**Town of Kittery
Planning Board Meeting
October 26, 2023**

ITEM 3 – 47 Cutts Road – Major Conservation Subdivision Plan – Preliminary Review

**RE: Town of Kittery, Planning Board Services
Cutts Road Major Conservation Subdivision – Preliminary Review
47 Cutts Road, Tax Map 60, Lot 10-3
CMA #591.164**

Sheet 1 - Overall Development Plan

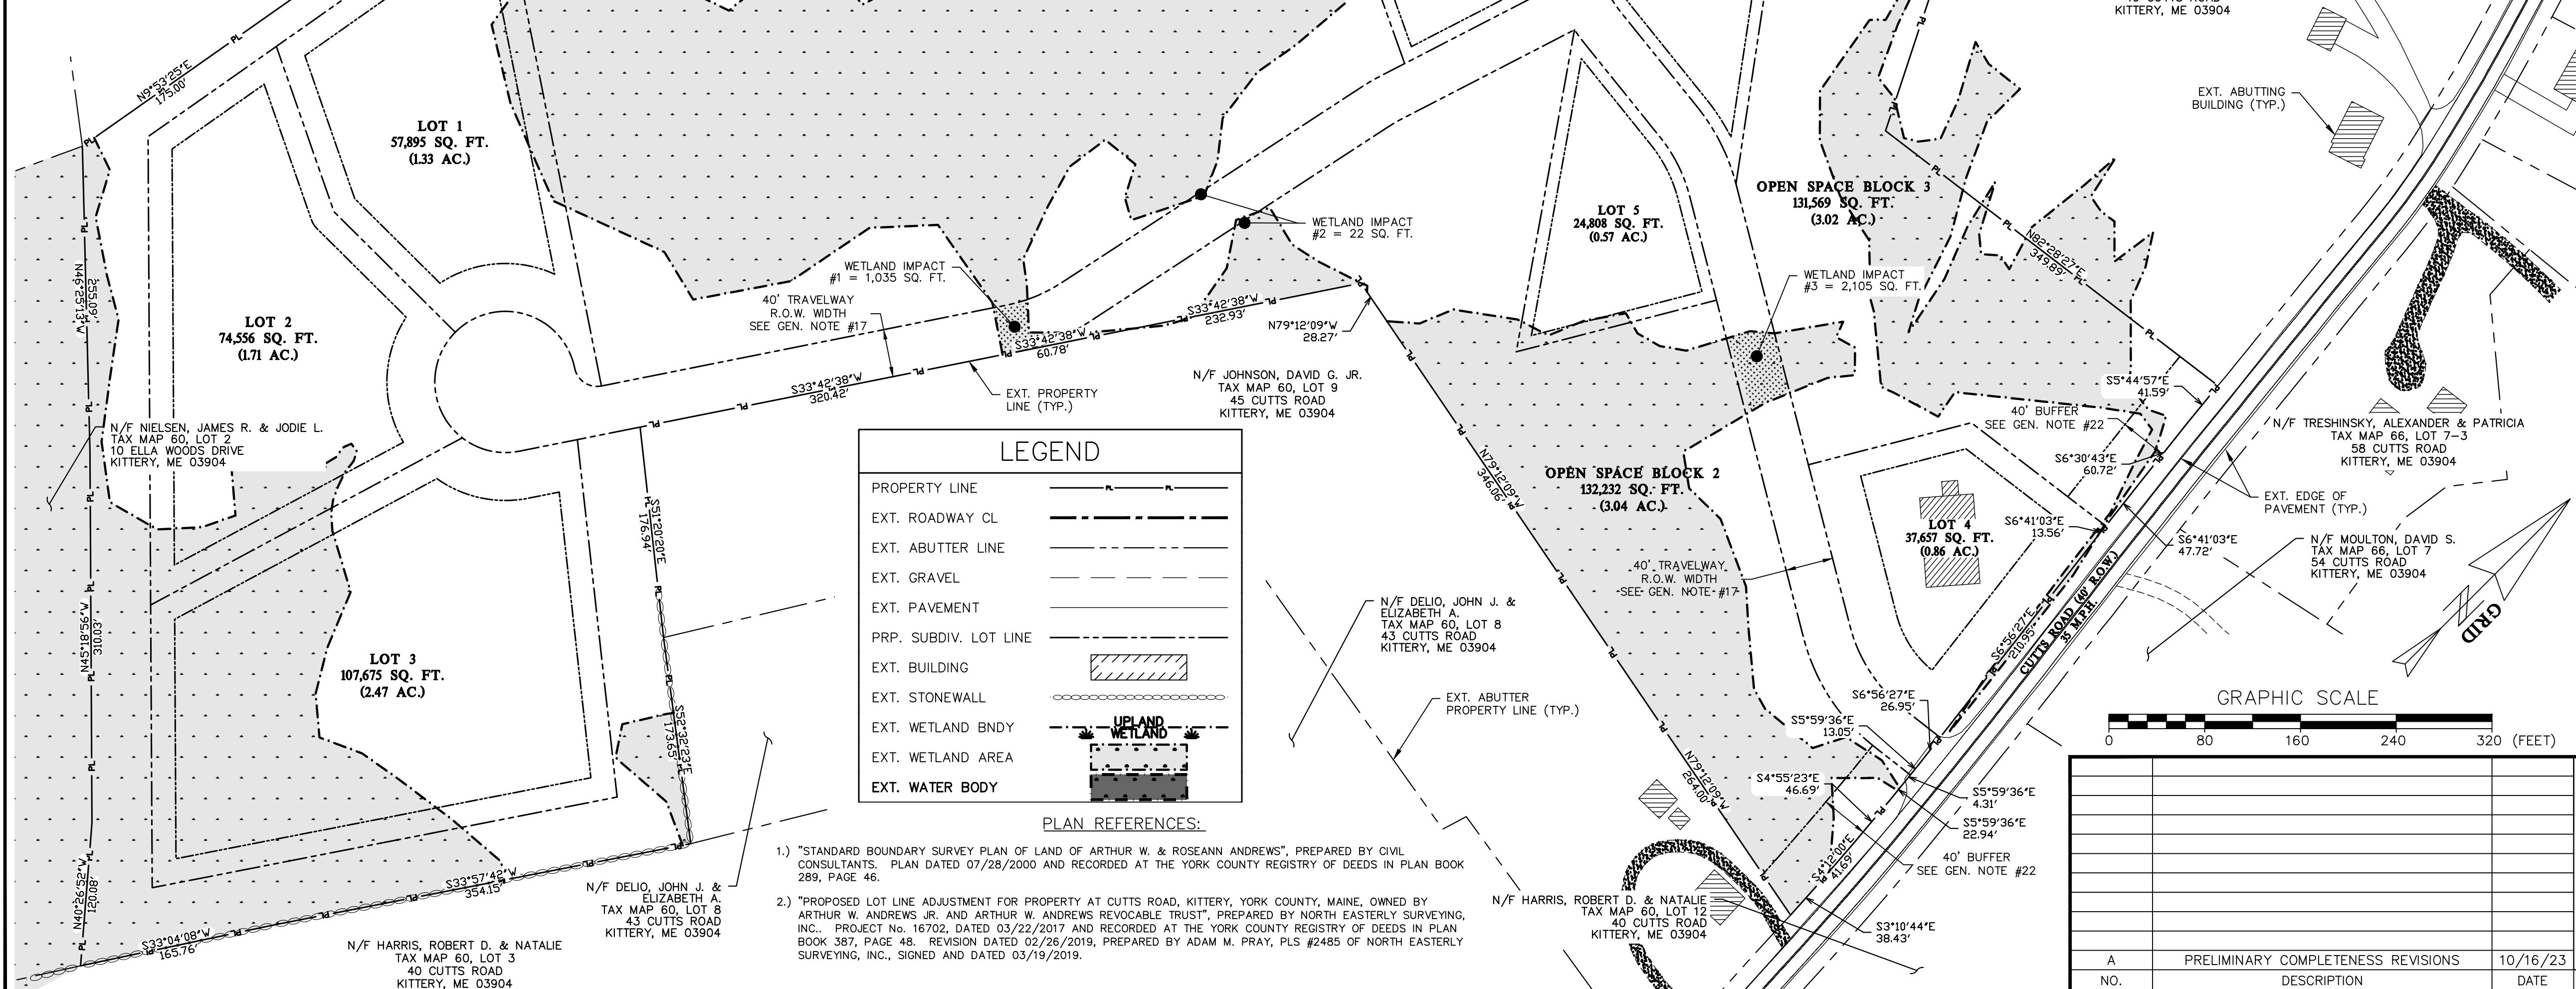
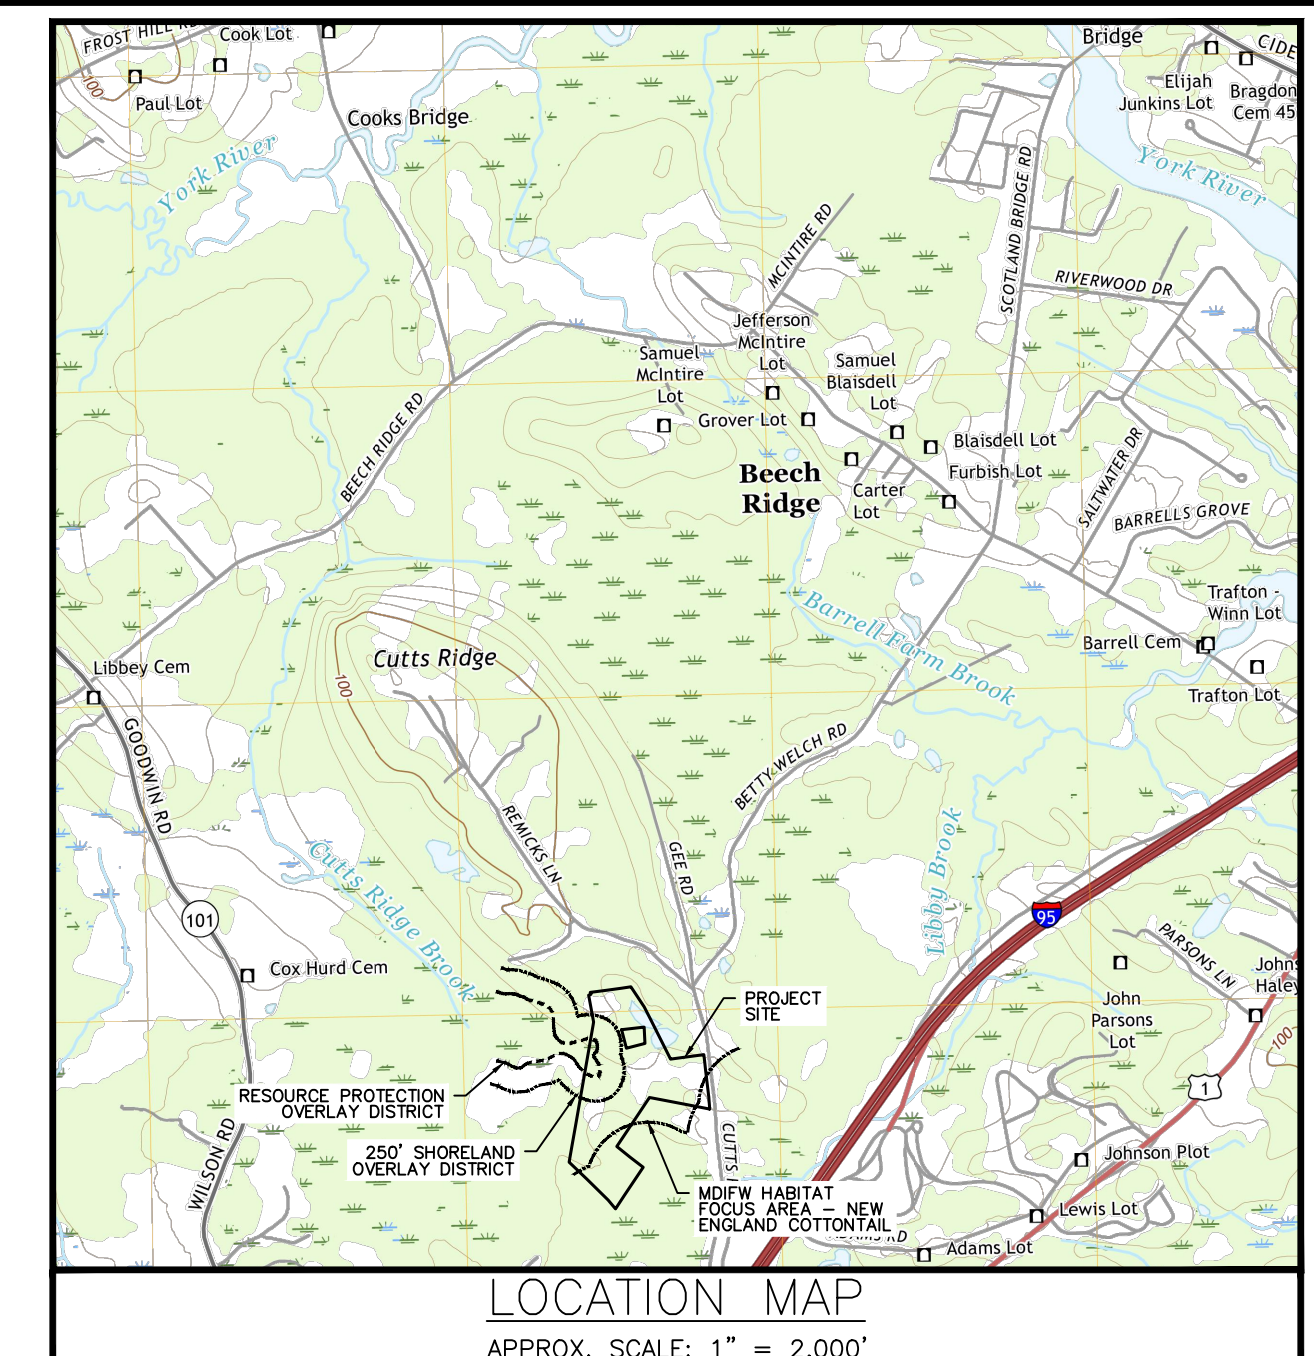
1. The plan should be stamped by the wetland scientist.
2. Notes 1 and 17 will have to be updated with the proposed roadway modifications.
3. Waiver requests will have to be updated with the proposed roadway modifications.
4. Note 19 should include calculations to demonstrate that the 40% minimum for open space of net residential acreage is met.

- The “Waivers Requested” section on Sheet 1 has been updated to reflect the travelway changes noted above, with the full list of waivers requested by the Applicant now reading:

- General Notes #1 & #17 on Sheet 1 have been revised to depict Class III travelway standards to reflect the revision described above.
- General Note #6 on Sheet 1 has been revised to include the proposed parking area to the list of subtractions from the Net Residential Acreage calculation. The revised calculation still shows compliance with the density requirements for this development (14 lots allowed, 13 proposed).

- General Note #7 on Sheet 1 has been revised to properly demonstrate that each proposed lot complies with the maximum Building Coverage requirement as per §16.4.10.D.(2).(e).

- General Note #8 on Sheet 1 has been revised to reflect the updated wetland impact total after the travelway redesign described above. Individual callouts for each wetland impact have also been added to Sheet 1 as requested by CMA.

- General Note #19 on Sheet 1 has been revised to demonstrate that the proposed Open Space complies with both sections of §16.10.7.A.(2) – specifically that 40% of the dedicated area must consist of net residential acreage.
